Subject: LaSalle County Nuclear Power Station Units 1 and 2
ComEd Response to NRC Staff Request for Additional Information (RAI)
Regarding Modifying the Main Steamline Tunnel Automatic Isolations
NRC Docket Nos. 50-373 and 50-374

Response to the RAI on MST T and ΔT

Figure 1: Sketch of Main Steam Tunnel - Existing Configuration

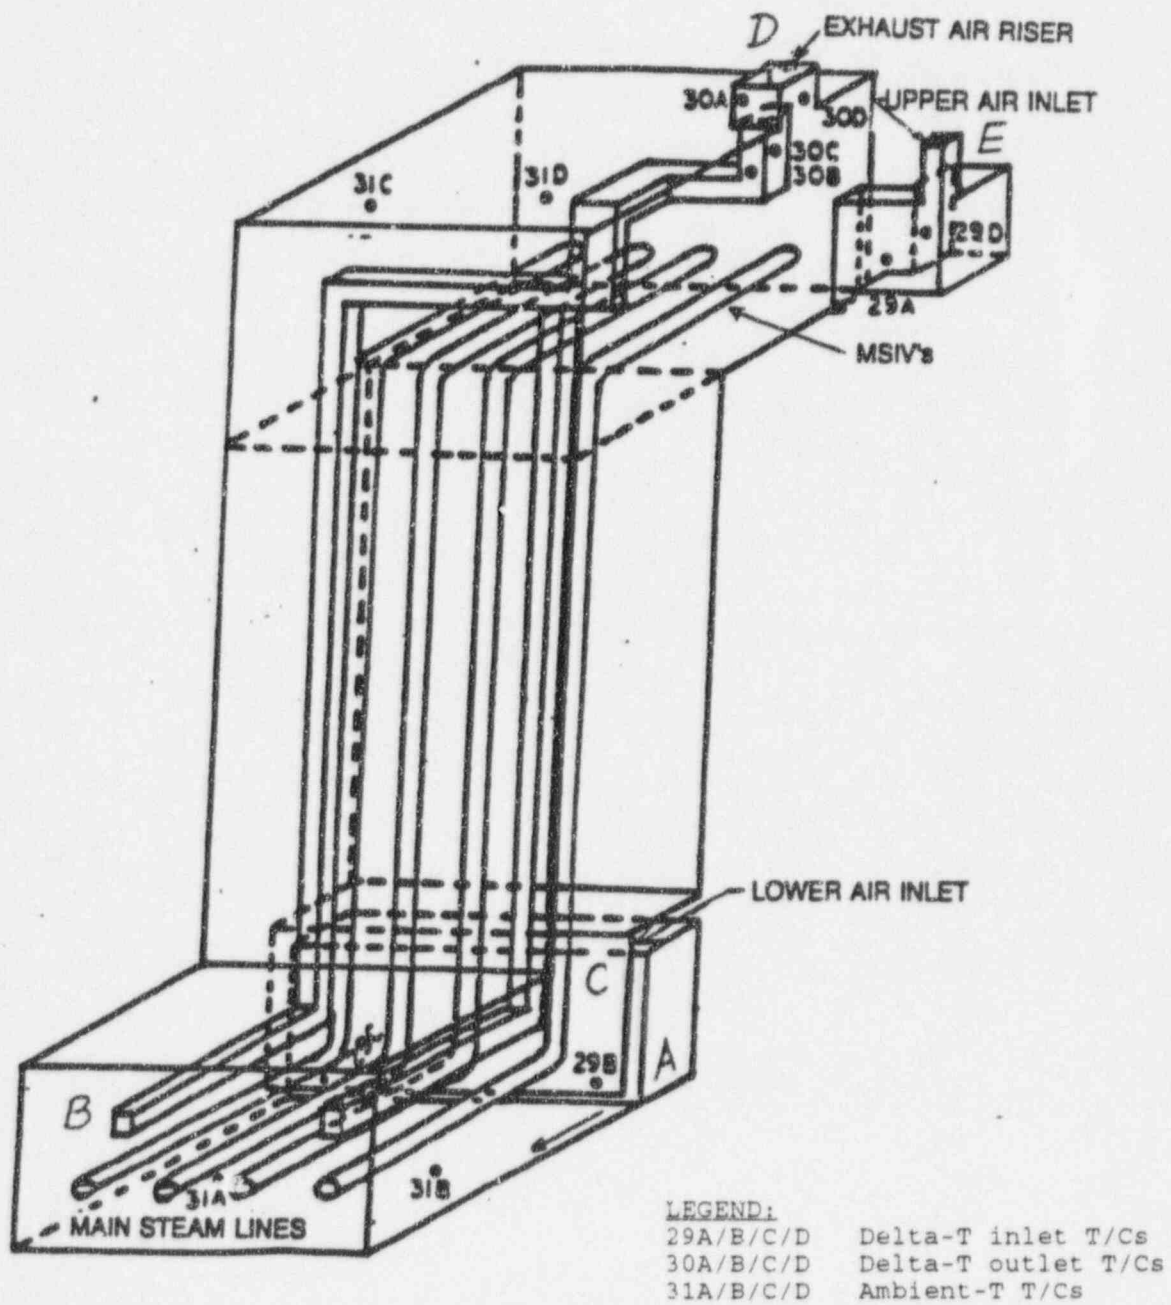
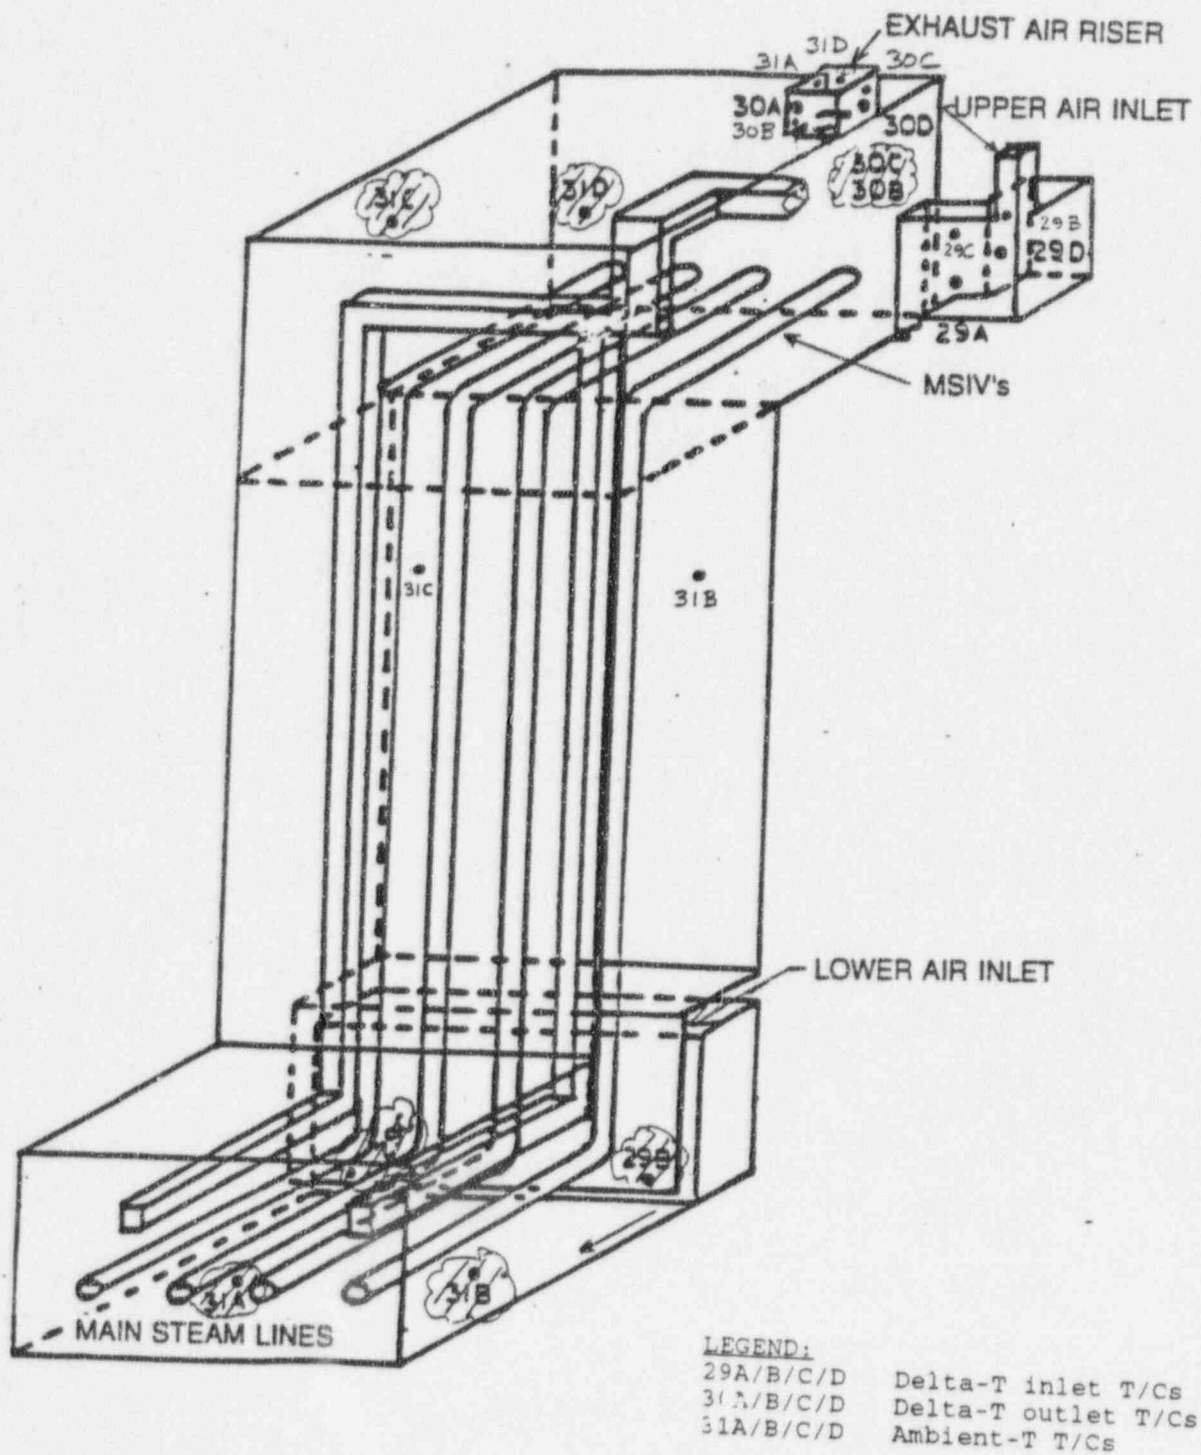
4. Relocation of Leak Detection Thermocouples in the MST - This change relocates the leak detection thermocouples in the MST to provide consistent leak detection monitoring for all four channels of differential temperature thermocouples (See Figures 1 and 1A). To provide uniform detection, all of the outlet temperature thermocouples will be relocated into the high velocity exhaust airflow discharge area of the MST. Similarly, all of the inlet temperature thermocouples will be relocated into the high velocity supply airflow discharging into the upper area of the MST. This will provide enhanced monitoring of inlet and outlet temperatures, without being affected by convective airflow patterns and dead spots in the more open parts of the MST. The high ambient temperature thermocouples are also being moved to locations that will provide a broader representation of the ambient temperature in the MST. This work is scheduled for L1R07/L2R07.

5. Removal of Section of VR Exhaust Ductwork - This change is being made in conjunction with the above thermocouple relocations and logic changes (See Figures 1 and 1A). The presence of this section of ductwork causes some of the exhaust airflow to be drawn directly from the lower elevations of the MST. Based on the new detector locations and trip logic, all of the MST exhaust airflow must be drawn from the top of the MST. Removal of this duct section eliminates the direct flow path from the lower area, thereby making the airflow patterns in the MST consistent with the new design approach for the leak detection system. This work is scheduled for L1R07/L2R07.

A sketch of the existing MST configuration is shown in Figure 1. In the analysis, the MST is subdivided into three areas denoted as the lower, middle and upper MST. The lower and upper MST extend from Elevation 687 to 706 ft and from Elevation 736 ft 7 in to 768 ft 4.5 in, respectively. The middle MST consists of the vertical section of the tunnel between Elevation 706 ft and 736 ft 7 in. The analysis is based on a proposed configuration without the exhaust flow path at B (see Figure 1A).

Figure 3: Benchmark Results

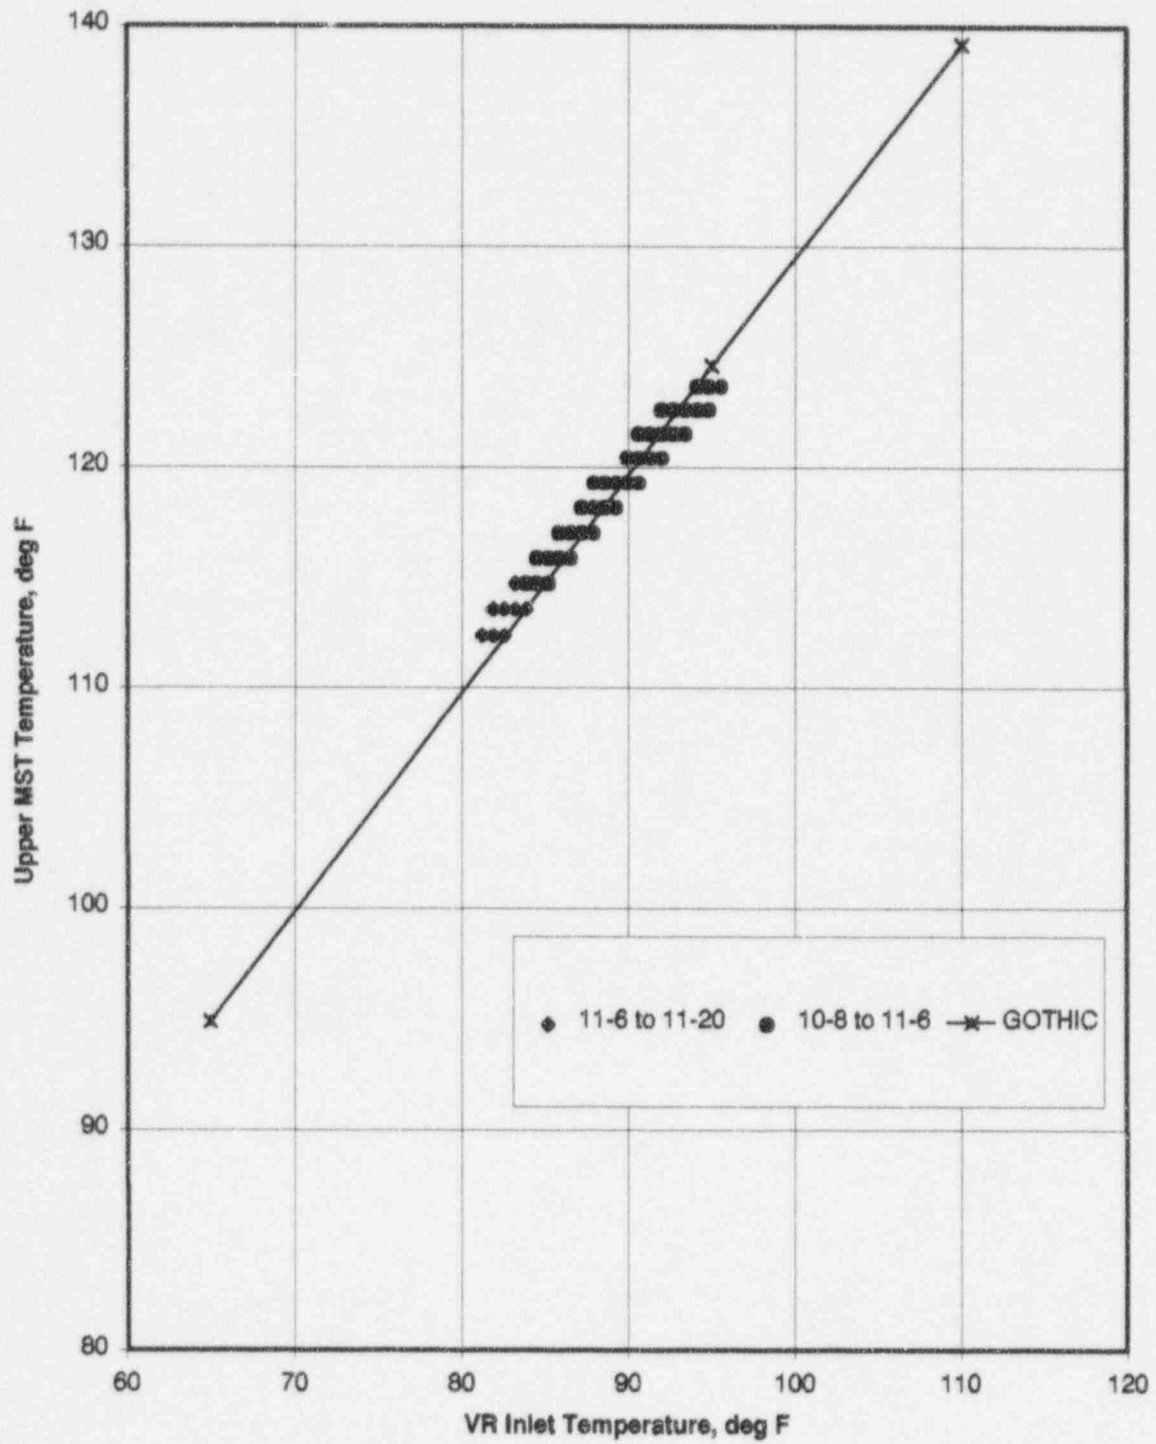
Provide a summary of the GOTHIC calculations, including the results for normal operating conditions in the main steamline tunnel (MST) which verify the analytical methods used to determine the differential temperature high-setpoint. Specifically, provide the conditions and the analytical assumptions shown on page G-3 of your submittal dated January 18, 1996.

The validity of the analytical model is established by comparing the GOTHIC model results with plant measured data. Figure 3 shows the results of the calculated upper MST temperature during normal operation at different MST inlet temperatures. The plant measured data taken in the period from October 8, 1995 to November 20, 1995 are also plotted in the same Figure for comparison. The plot shows very good agreement between the calculated results and plant data.

Figure 4: Upper MST Temperature Response for 110 deg F VR Inlet, 100 gpm

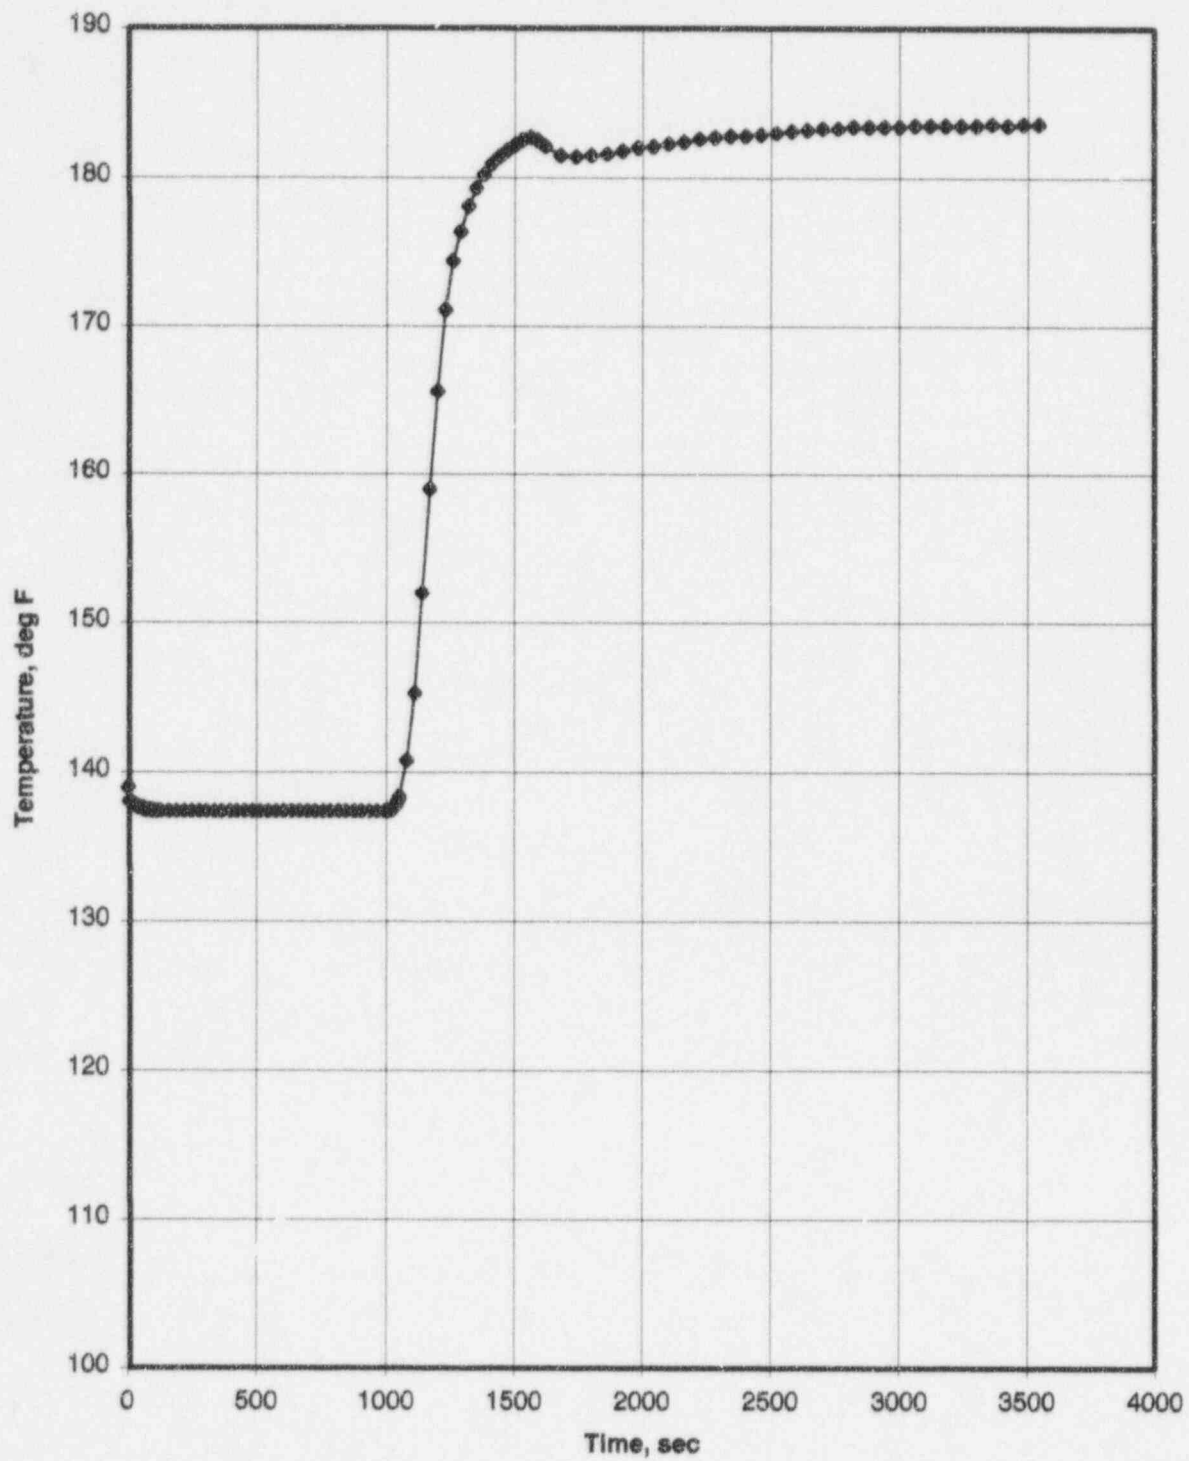
On page G-2 of your submittal, you state that your analysis assumes that a crack develops and that a subsequent steam leak develops over a period of 100 seconds. State what the effect of variations in this assumption regarding the time interval. Provide quantitative examples using the same analytical methods.

Figure 4 shows the upper MST temperature response as a result of 100 gpm of steam leakage. The MST inlet temperature is 110 °F and the leak is initiated at time equal to 1000 sec. (This initiation time is arbitrarily chosen and does not affect the results as long as the model is at a steady state condition prior to leak initiation.) The temperature increased 45.1 degrees from 137.4 to 182.5 °F in the first 10 minutes but added only 1.1 degrees in the next 30 minutes. The quick temperature response is typical for all the

Figure 5: Upper MST Temperature due to Steam Leakage in the Lower MST

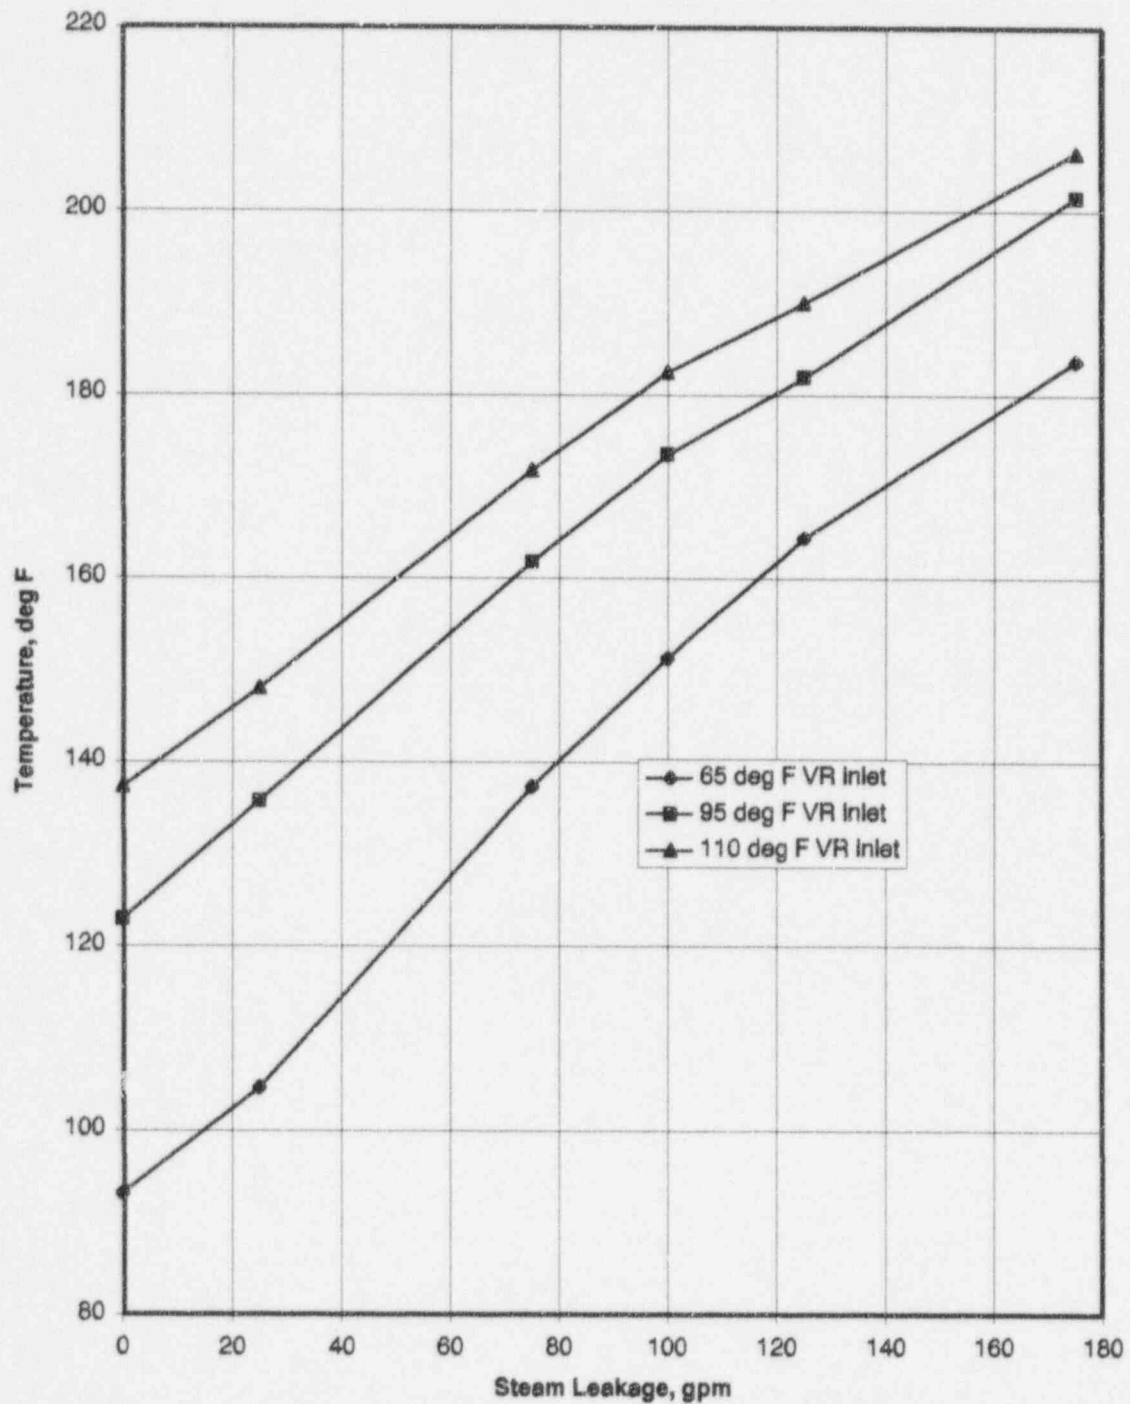
You state on Page A-9 of your submittal that in the event that the reactor building ventilation system is inoperable, compensatory measures will be used to monitor for leakage in the steam tunnel. You also state that these compensatory measures are those approved by the NRC staff in its letter from J.B. Hickman, NRC, to T.J. Kovach, CECO, dated March 21, 1991. Estimate the time required to detect steam leakage when these compensatory measures are in effect, assuming a steam leak of 100 gpm. Discuss the operator's response required by these compensatory measures after leakage detection. State whether the alarm function indicating an ambient temperature-high, will be retained. If the MST ambient temperature-high can be used as a compensatory indication of leakage, explain why it can't be retained as a primary indication initiating an automatic isolation with the setpoint raised to a value of temperature sufficiently high so that a spurious trip is precluded.

Figure 5 shows the upper MST temperature for different leakage rates and for different MST inlet temperatures. These are the temperatures at approximately 10 minutes after the leak. In most cases, the temperature has reached a steady state value, and if it has not, it is very close to the steady state value. The results show that the temperature varies directly with the quantity of steam leakage. For a given leakage rate, the upper MST temperature is highest for a MST inlet temperature of 110°F and lowest for a MST inlet temperature of 65 °F. The upper MST temperatures at 10 minutes for a 100 gpm leak are 151.3, 173.5 and 182.5°F respectively for MST inlet temperatures of 65, 95 and 110°F. Corresponding to these MST inlet temperatures, the temperatures for no leak condition are 93.2, 122.9 and 137.4°F. Although the results indicate that the lowest calculated temperature (151.3 °F for 65 °F inlet temperature) for 100 gpm leak is higher than the highest temperature for no leak (137.4°F for 110°F inlet temperature), the temperature experienced in the MST when the VR system is out of service has been observed to be greater than 151.3°F. Therefore, a single year-round high temperature setpoint that would preclude spurious trip can not be established based on an allowable leakage of 100 gpm. (See response 7 for additional details.)

The MST ambient high temperature is not being utilized as an isolation trip because of difficulty in selecting a meaningful setpoint. The temperature setting for a 100 gpm leak would need to be approximately 150°F for winter operational conditions (see Figure 5, Upper Steam Tunnel Temperature due to Lower Steam Tunnel Leakage, for 65°F case). In the bounding summer time condition of MST inlet temperature at 110°F, the upper MST temperature would be 138°F during normal operation (see Figure 5, Upper Steam Tunnel Temperature due to Lower Steam Tunnel Leakage). Based on plant historical data, the shutdown of VR results in an increase in MST temperature of 32°F within the first 10 minutes. A shutdown of VR in the bounding summer time condition would then result in a MST temperature of 170°F within the first ten minutes with subsequent temperature increases until the temperature equilibrium is reached. The MST ambient high temperature setpoint necessary to preclude a spurious trip on shutdown of VR would need to be greater than 190°F (including setpoint tolerance, response time, etc.), and would not be of practical use during the predominate condition of normal VR operation. It was not thought appropriate to set the MST ambient high temperature isolation trip to such a high value, because the higher temperature setpoint of greater than 190°F would correspond to greater than 180 gpm leakage in the lower bounding condition (See Figure 5). By maintaining the MST ambient high temperature as an alarm, the setpoint can be maintained at a lower value than that which would be required for an isolation trip setting to provide the Operator early indication of MST steam leakage under normal operational conditions. Operator action can then be taken to identify, quantify, and isolate the leakage, with an orderly shutdown of the Unit prior to isolating the steam lines, if necessary. Overall safety is improved by not challenging the Unit to the pressure and reactivity transient resulting from spurious MSIV closure with the resulting SCRAM.
